# CD-CPC-2025-00041

The applicant is seeking approval of a major amendment to a previously approved development plan to construct two new commercial buildings on the subject site.

Neighborhood Planning and Development Committee

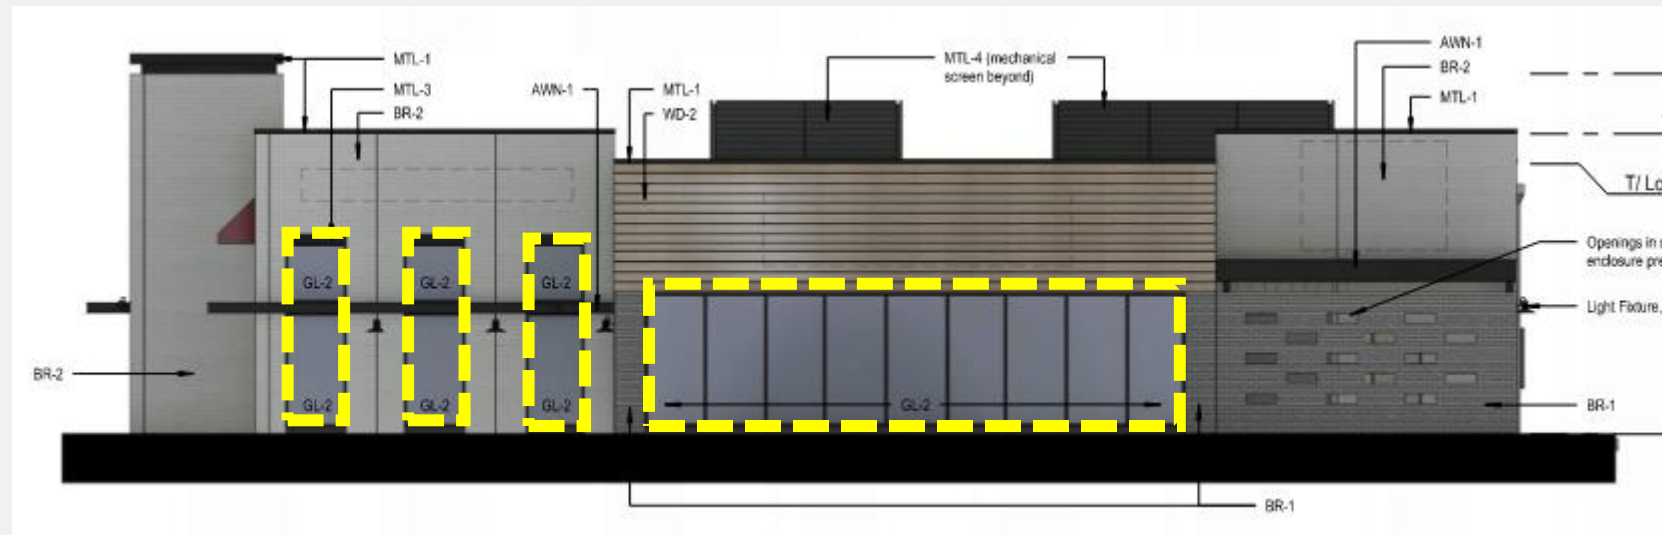
- Yes, if the variances (5/14 BZA) to the parkway transparency standard are approved, the proposed project would comply with the zoning and development code. AN
- The proposed project has received a low–medium alignment with the area plan and KC Spirit Playbook due to development context and form guideline issues. See the KC Spirit Playbook and Area Plan Checklist for more information. SC

- If adjacent to and within 150 ft of a parkway, structures shall provide a minimum of 33% transparency on the ground-level façade facing the parkway.
- 88-810-2165 defines transparency as “windows or doors that allow clear views of indoor spaces. To qualify as transparent, windows or doors shall not be mirrored, darkly tinted, or of any material that obscures visibility between the inside and outside.”
- The applicant has requested a variance to this requirement.
- Variances approved for last Development Plan.

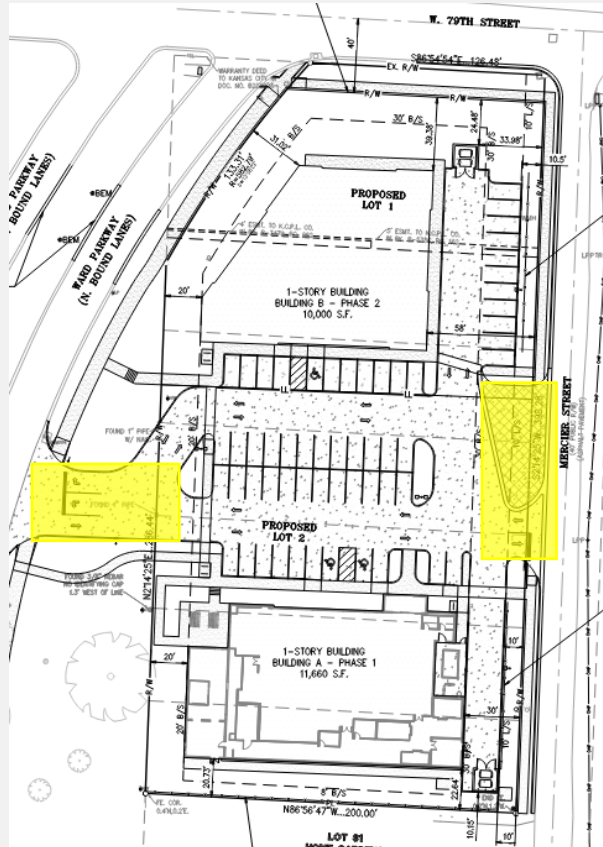
- Access points off of Ward Parkway and Mercier St
- Mercier St access point - very large, especially considering the access point is adjacent to an established residential neighborhood.
  - The design of the Mercier St access point accommodates the semi-trailer traffic, with the rear wheels using the stamped concrete area (not permeable) when semi-trailers enter/exit the site. Though not ideal, the site's alternative access points, Ward Parkway or W 79th St, also a busy intersection, are less favorable considering loading traffic.
